CITY OF ALBUQUERQUE

Re: Uptown-Sandia View Assisted Living
8211 Cutler Avenue NE
Traffic Circulation Layout
Engineer's/Architect's Stamp 02-04-2020 (H19D089)

The TCL submittal received 03-24-2020 is approved for Building Permit with. A copy of the stamped and signed plan will be needed for each of the building permit plans. Please keep the original to be used for certification of the site for final C.O. for Transportation.

SHEET NUMBER:
TCL-101

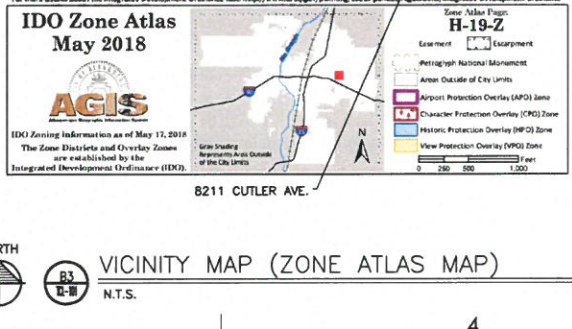
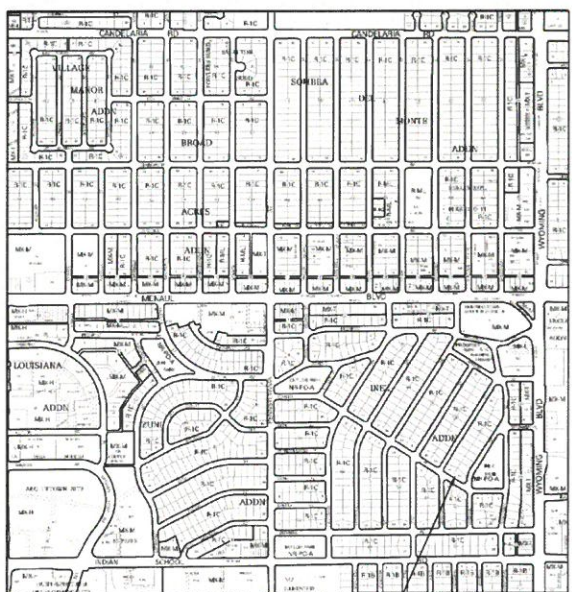
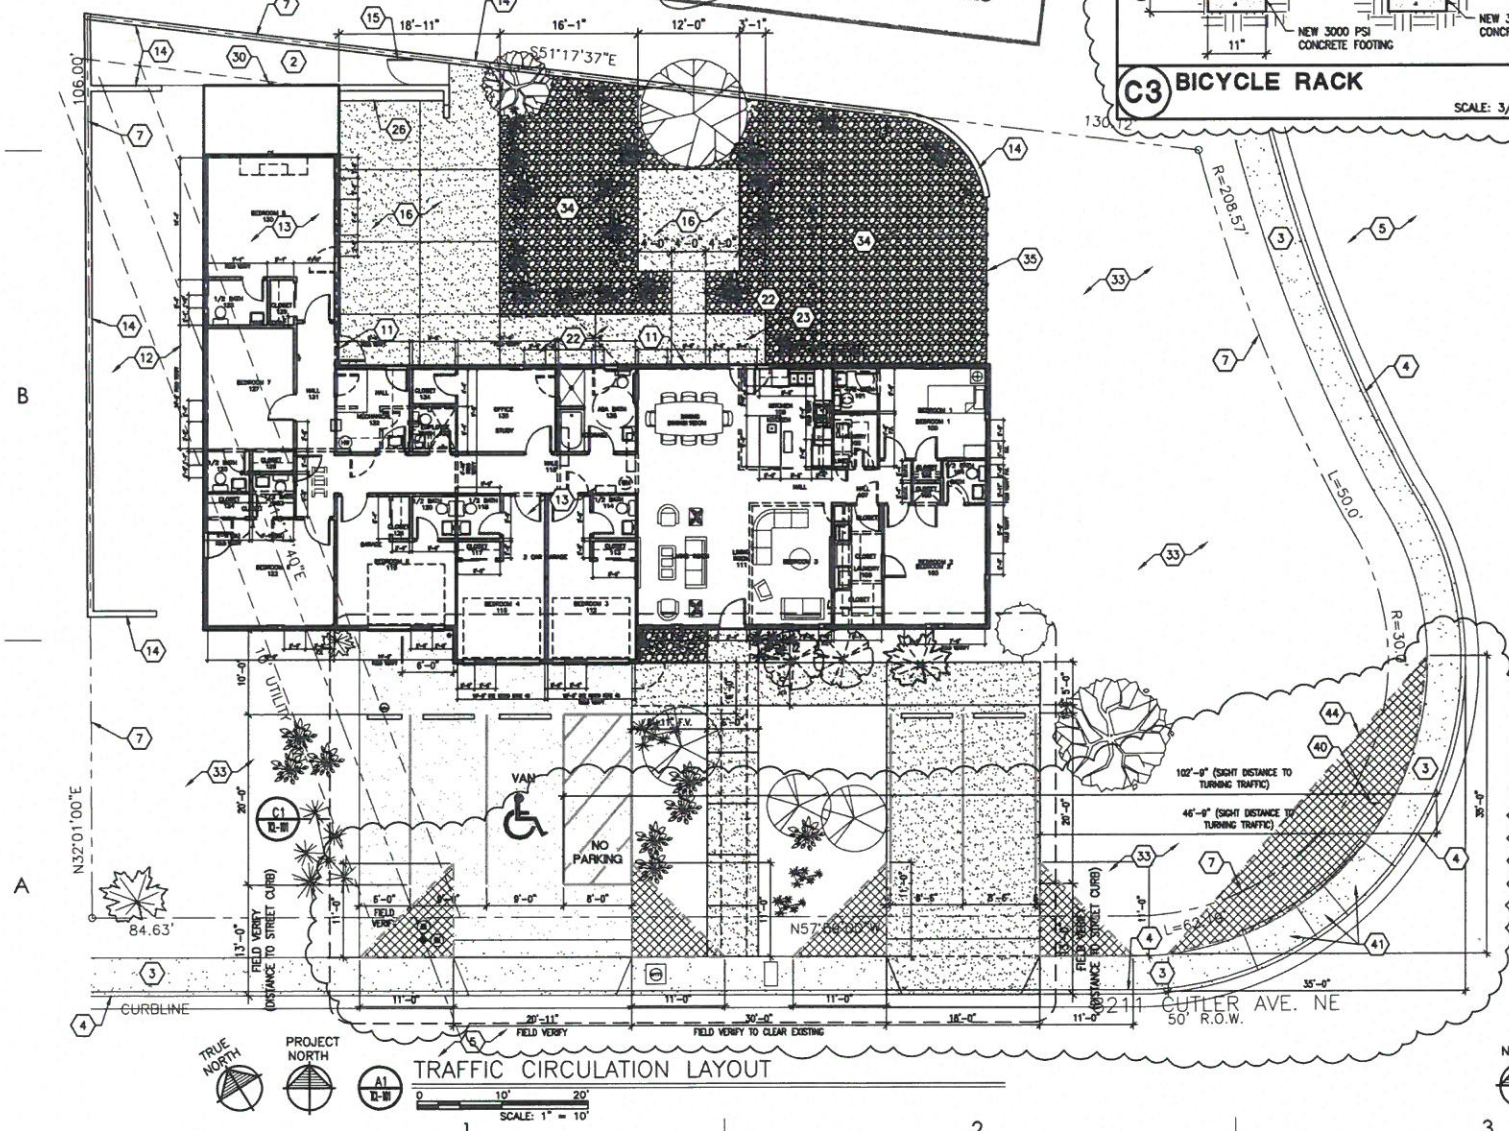
ALL WHEELCHAIR RAMPS LOCATED
WITHIN THE PUBLIC RIGHT OF WAY
MUST HAVE TRUNCATED DOMES.
